RFI

Job: EB-02 Keller Springs Lofts

Subject: Structural Repair Needed at Step From Pour 3 to Pour 5

Subject: Slab Overpour at Pour #1

Subject PFI ~ 13 | Calc'd By Chk'd By Sht Of

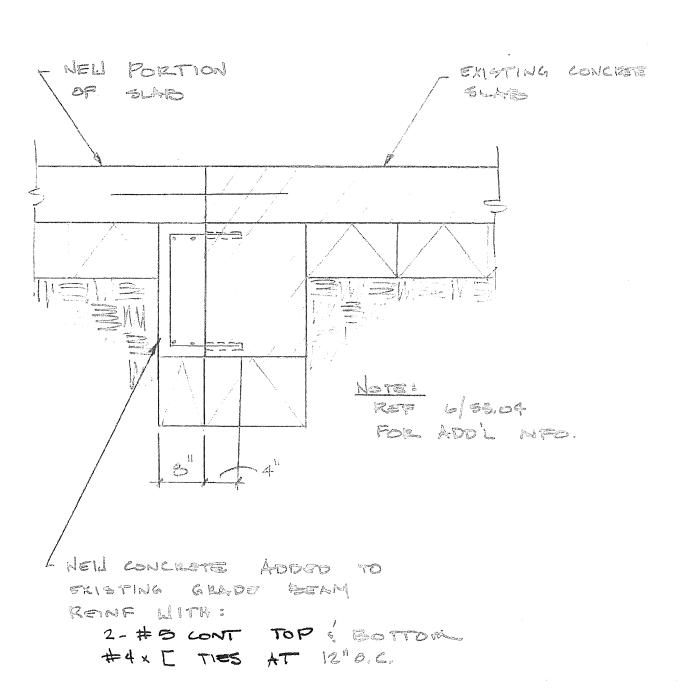
The slab at the northeast corner of Pour #1 was overpoured to cover the entire gradebeam instead of half of it. Please provide method to repair.

Please see attached sketch for PPO's suggested solution.

Architect to verify that the presence of this cold joint inside the unit is acceptable.

BGO is in concurrence with PPO's structural detail. Please do not oversize the holes for the dowels. Provide Greenstreak Swellstop Waterstop (http://www.greenstreak.com/Div3/Waterstops/swellstop.asp) or approval equal in the joint,
